Supplemental Supporting Information for a Finding of Effect

Project: Bridge #2016 - Frank J. Wood Bridge / WIN 22603.00 / STP-2260(300)

Pack Rust Removal Work Plan

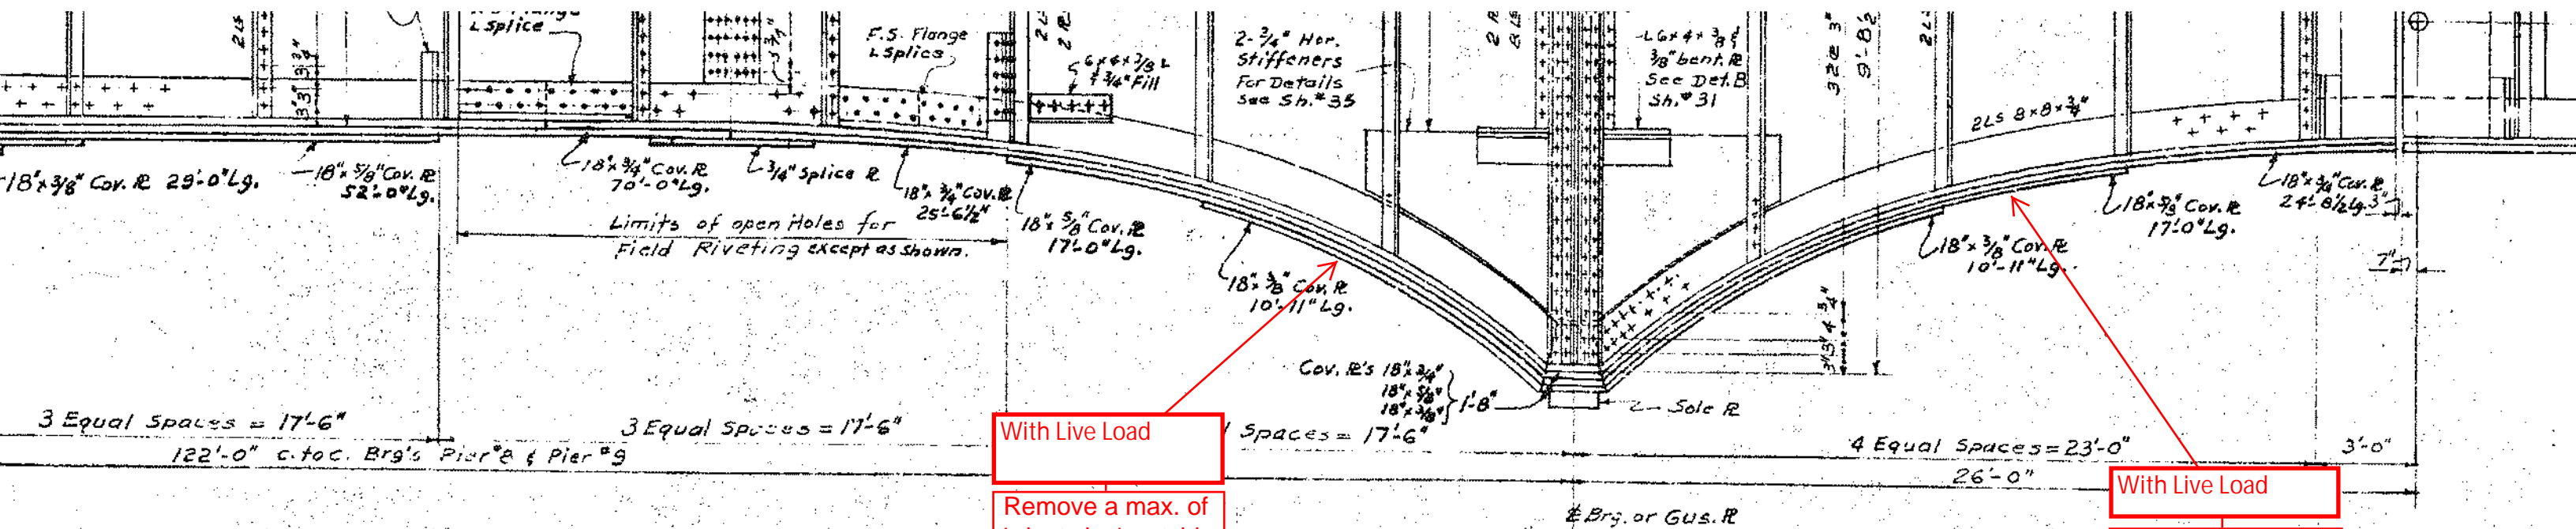
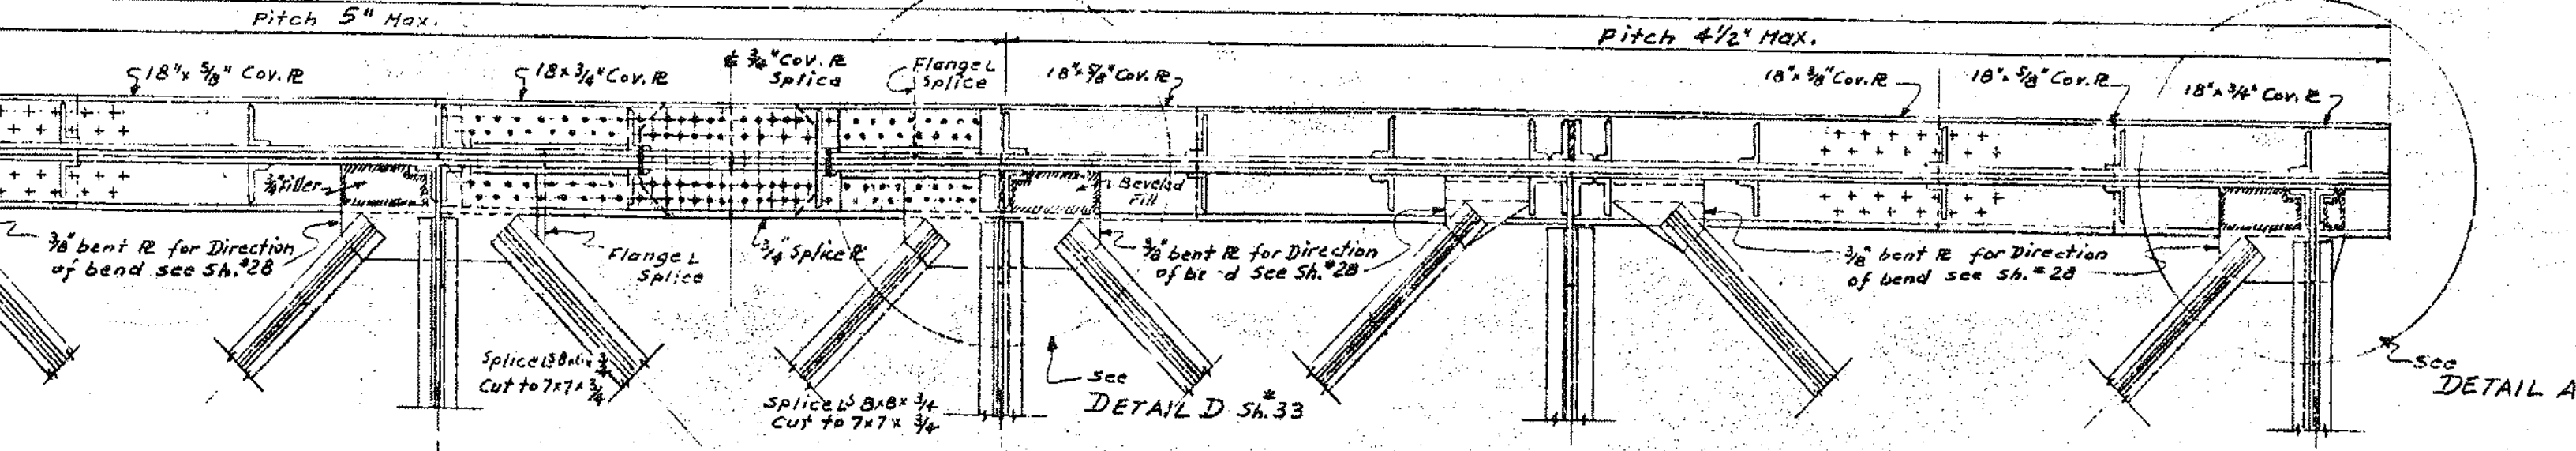
The October 27 Summary document in Figure 15 states the following: "*The only way to truly fix pack rust is to take apart the plates of steel and clean them, which is usually not feasible.*" This suggests that the Department's position on pack rust is that pack rust cannot be corrected or repaired without full disassembly of built-up members. This statement is not correct, and I request the re-evaluation of rehabilitation using methods of pneumatic pack rust removal currently in-use in other states. A summary follows:
